**ADDENDUM NO. 01**  
**Date: January 28, 2022**

To Drawings and Specifications dated December 6, 2021:

**HCC Renovations**  
**Central South, Eastside, Northeast, and Stafford Campuses**  
**Harris County, Texas**

Collaborate Project No.: 2135

**A1.10**

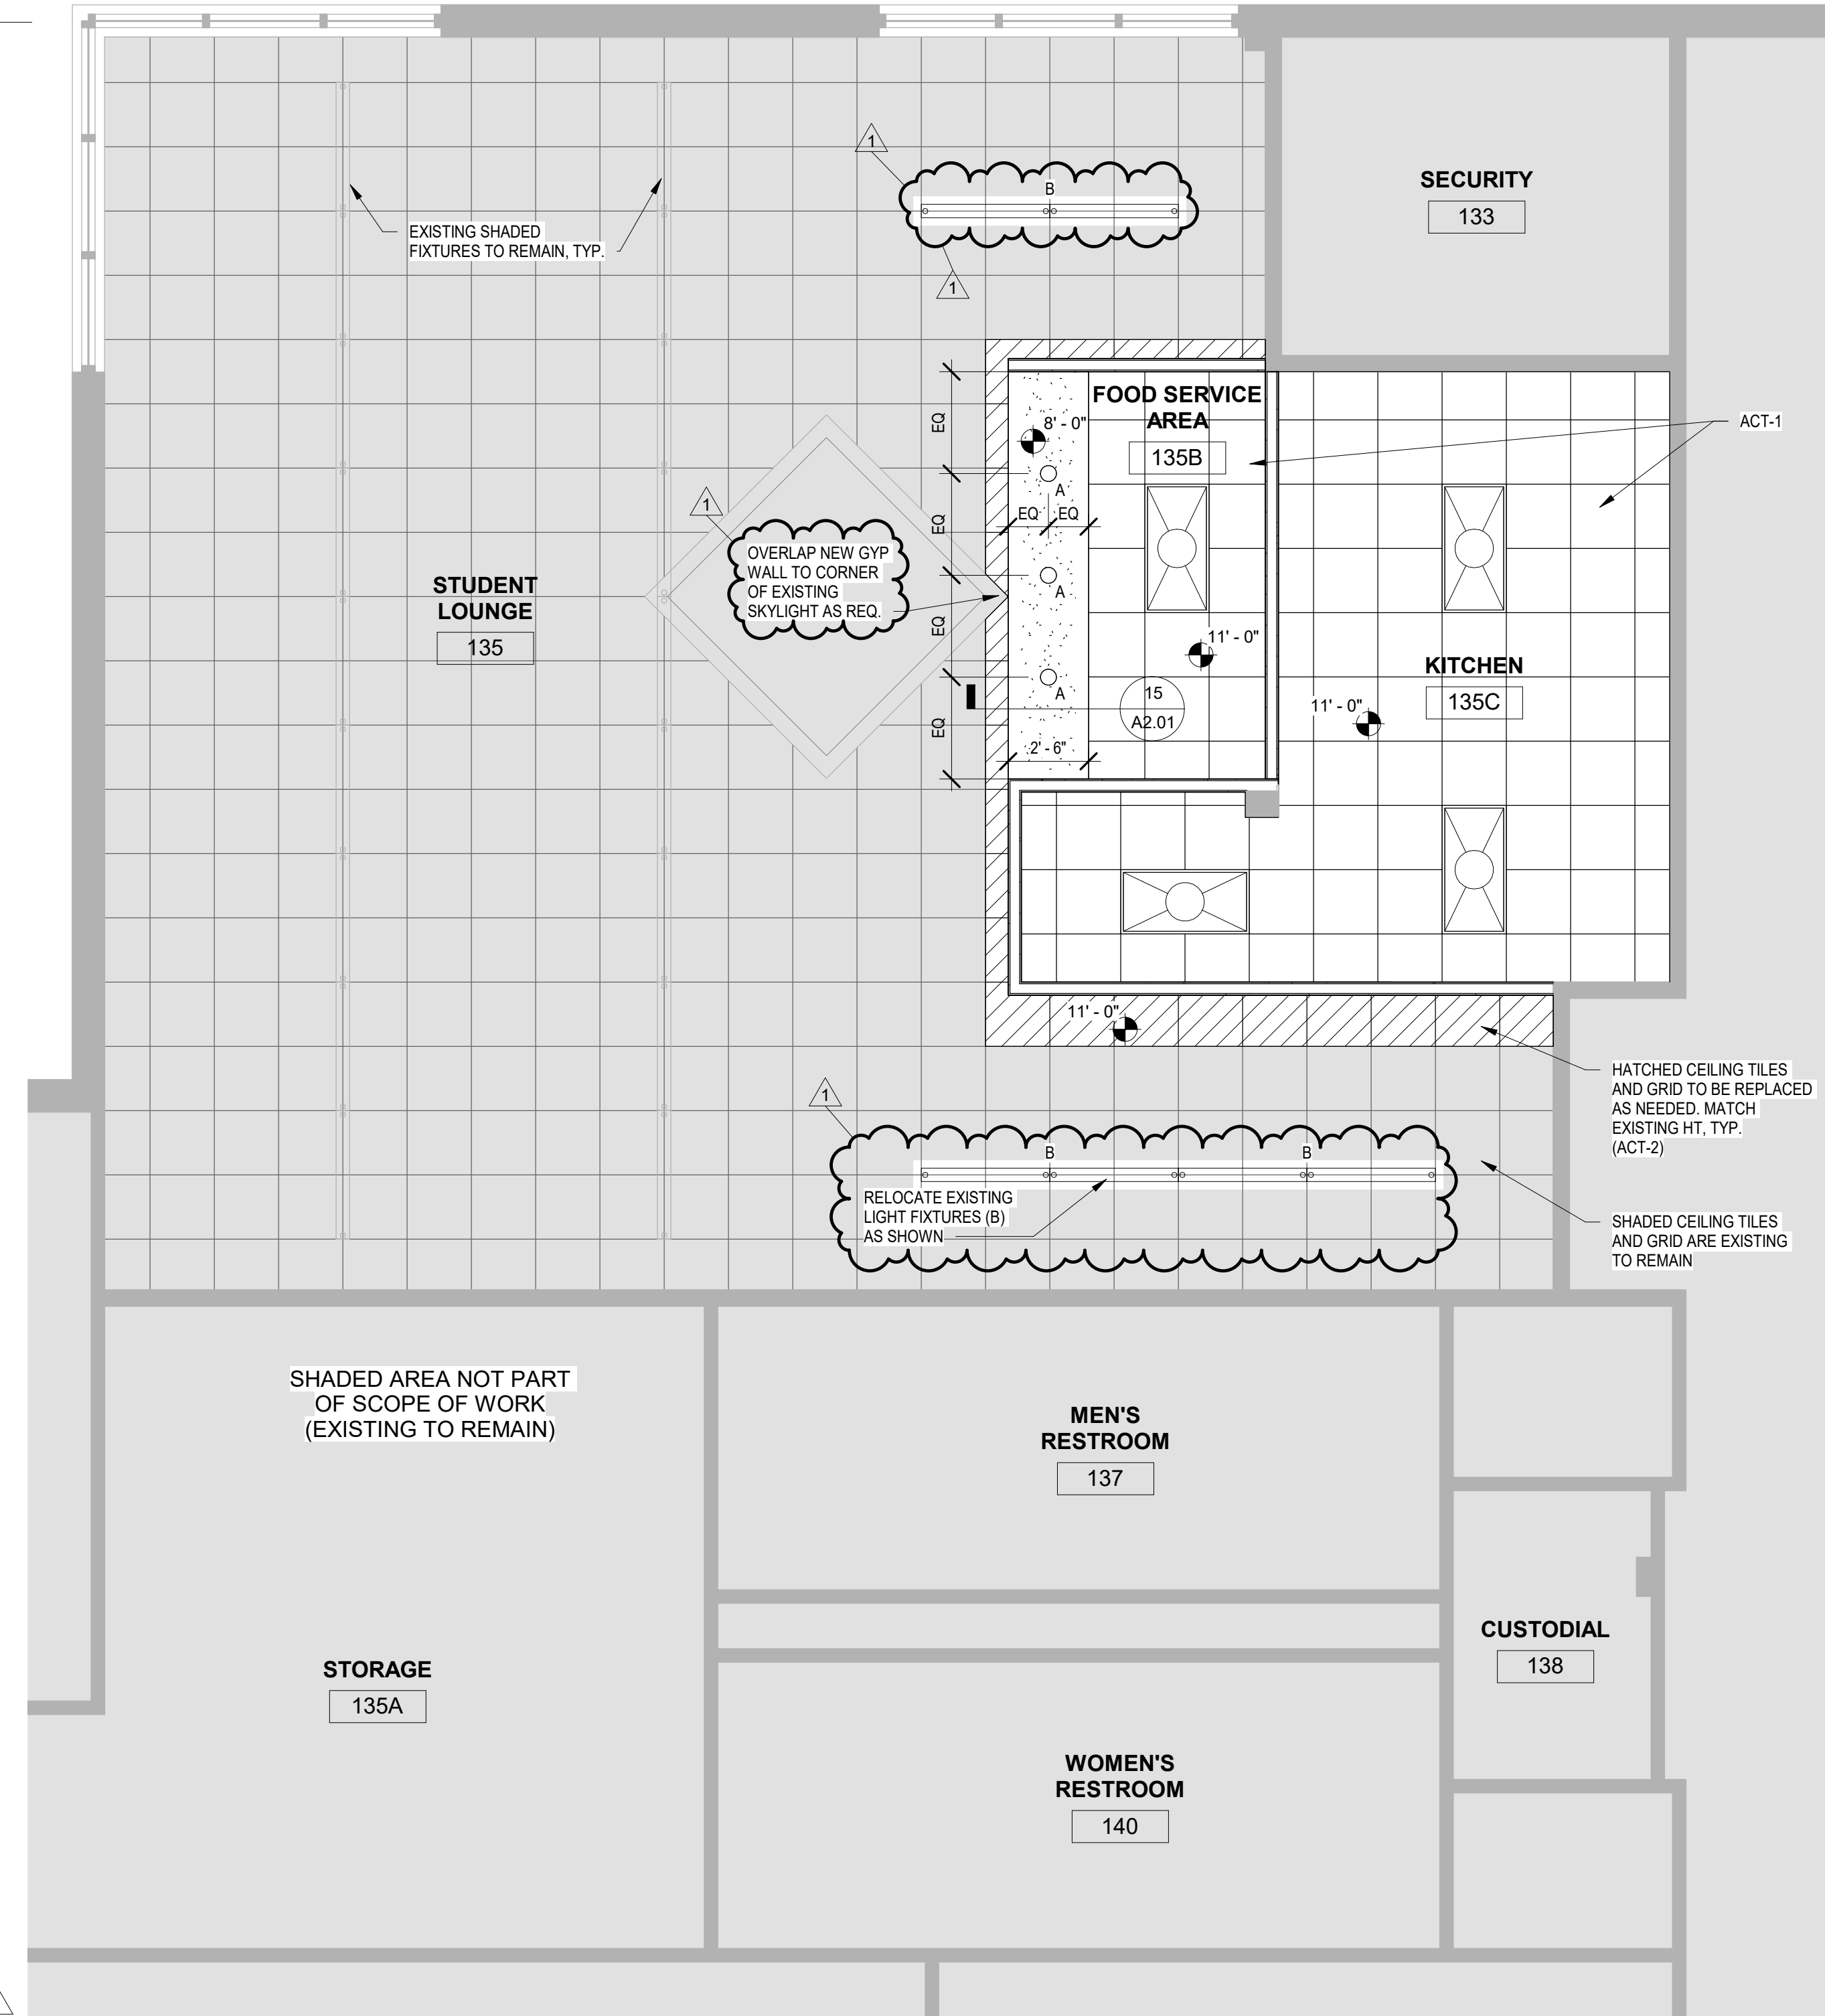
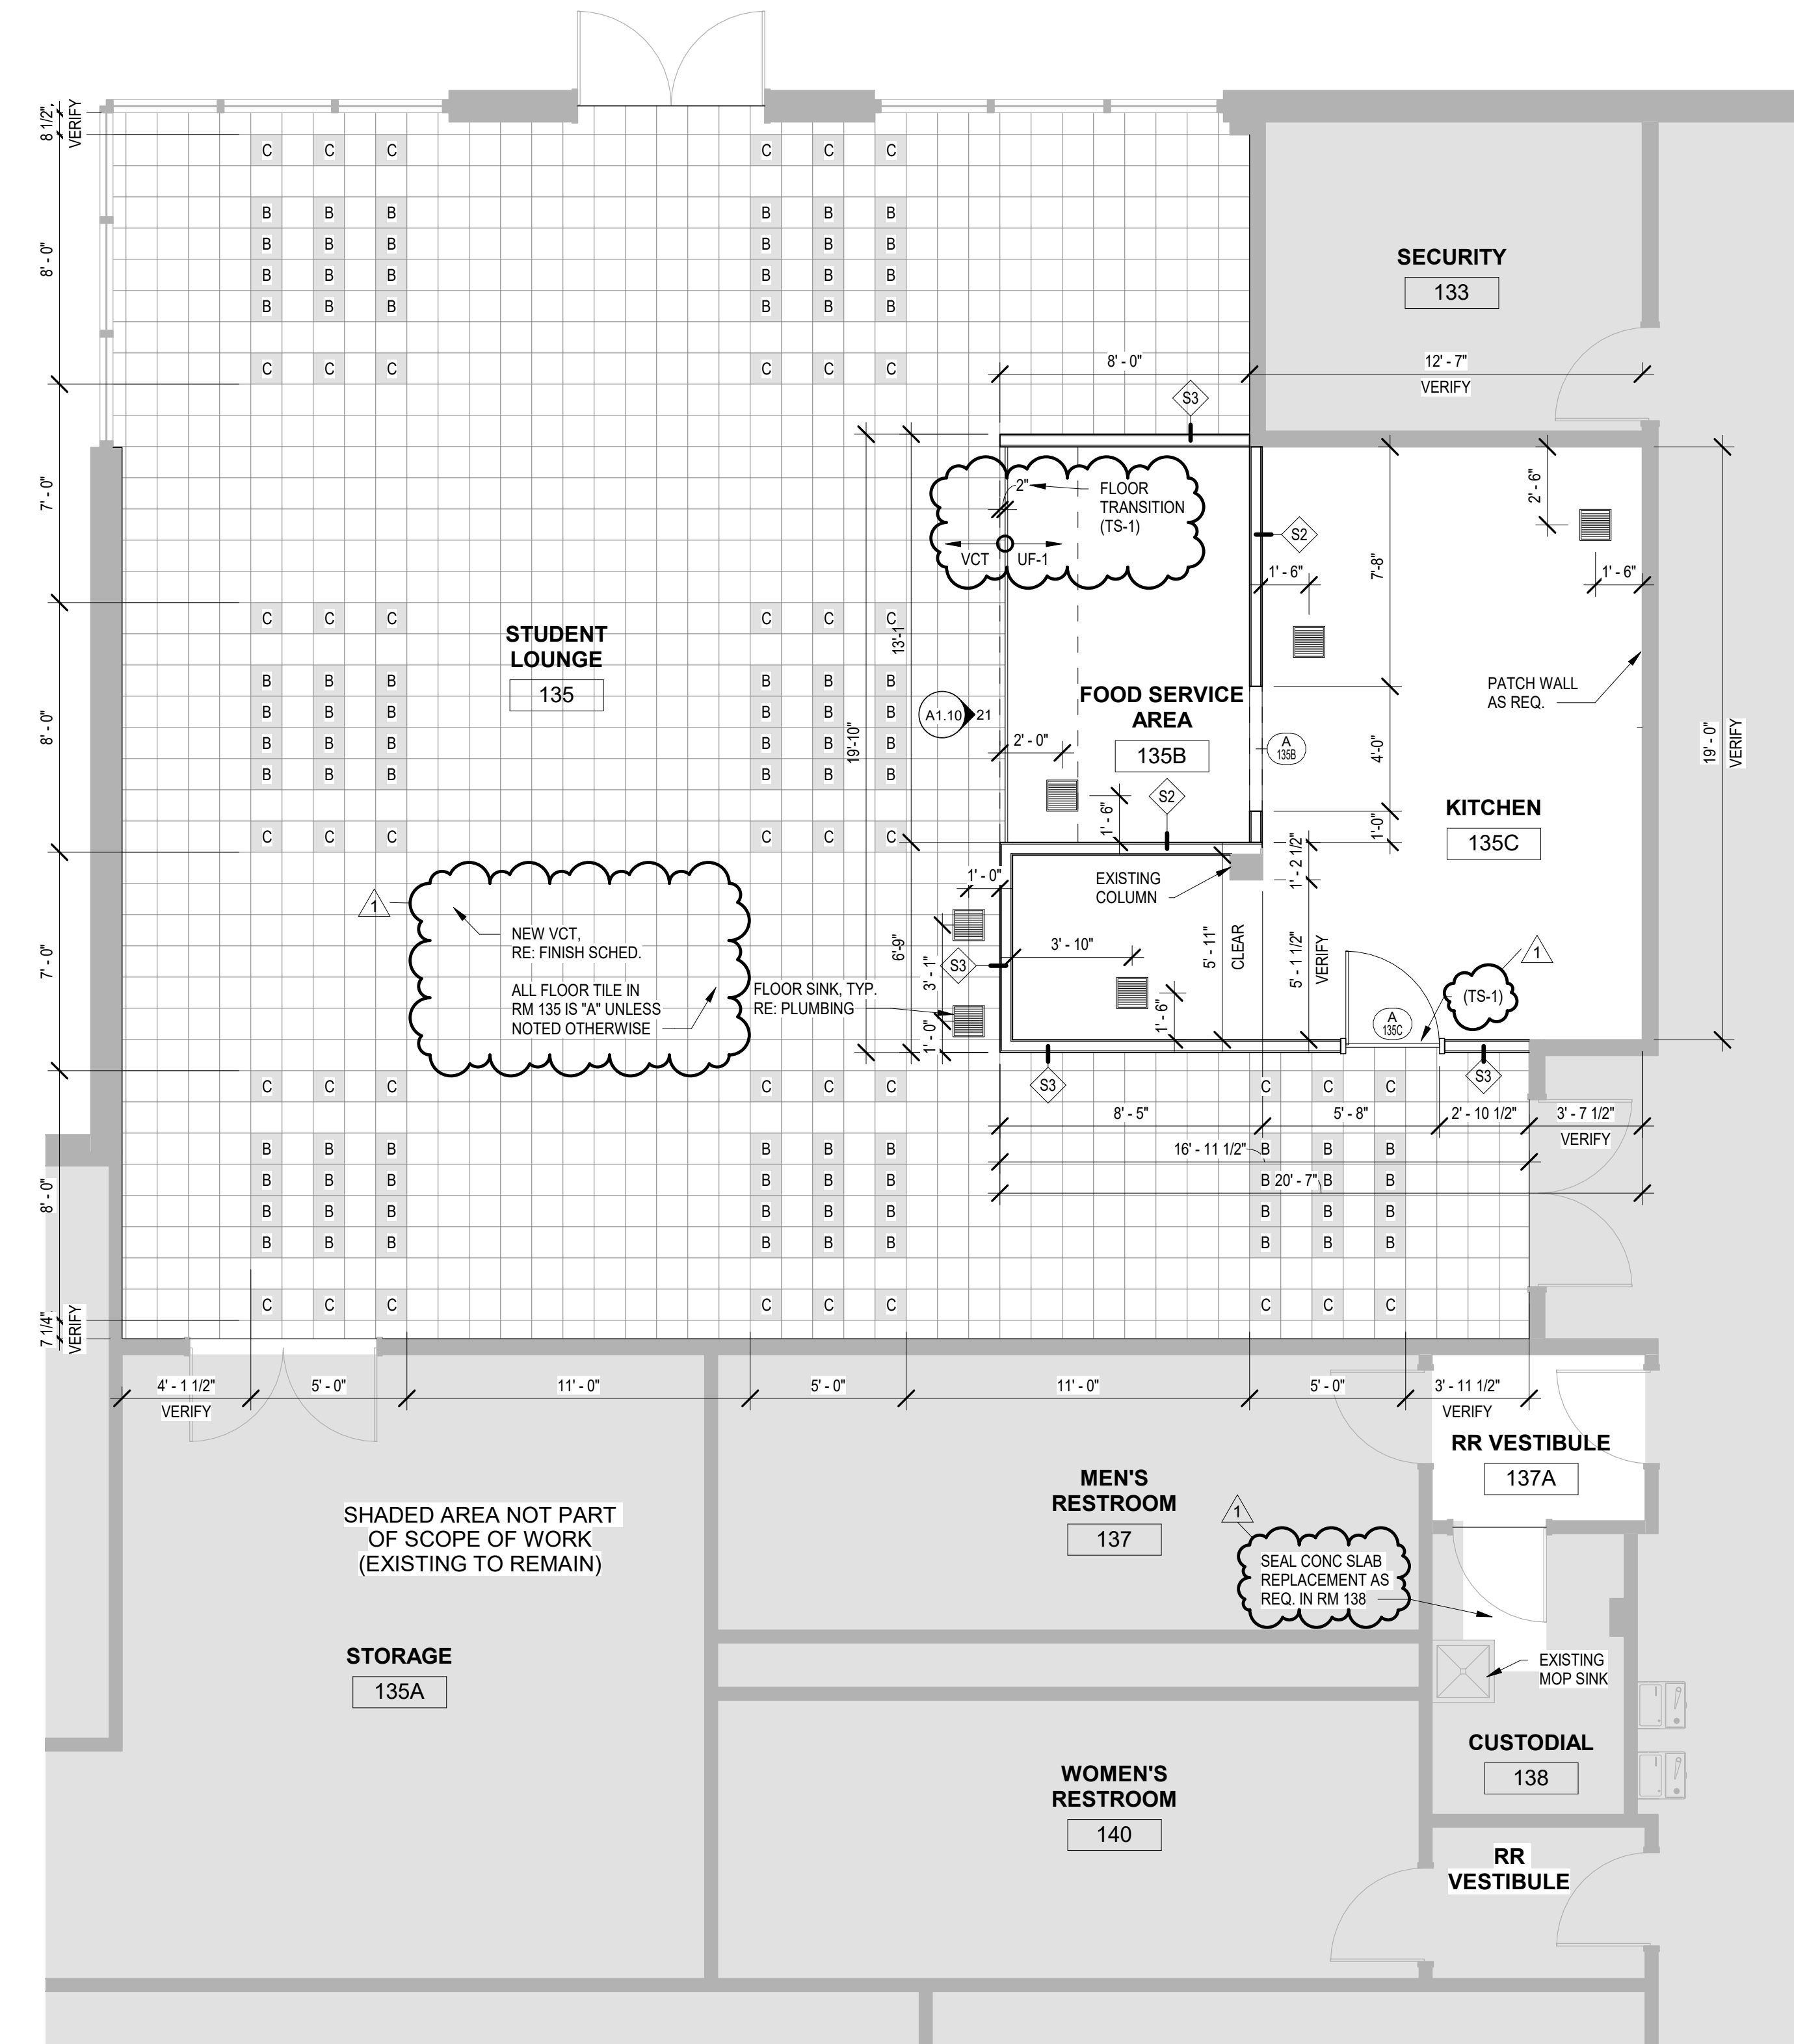
- Item No. 11 **Question:** At the Central South campus where the VCT is to be replaced, does HCC have attic stock, or do we have to provide samples to architect in order to match to existent?

**Response:** Replace all VCT flooring in the Student Lounge. Refer to attached Drawing A1.10 for the new pattern and VCT description.
- Item No. 12 **Question:** At the Stafford campus, does client want to add FRP to new partition walls in order to match to existent wall design around the rest of the building. Do we simply build new partitions with finish paint schedule?
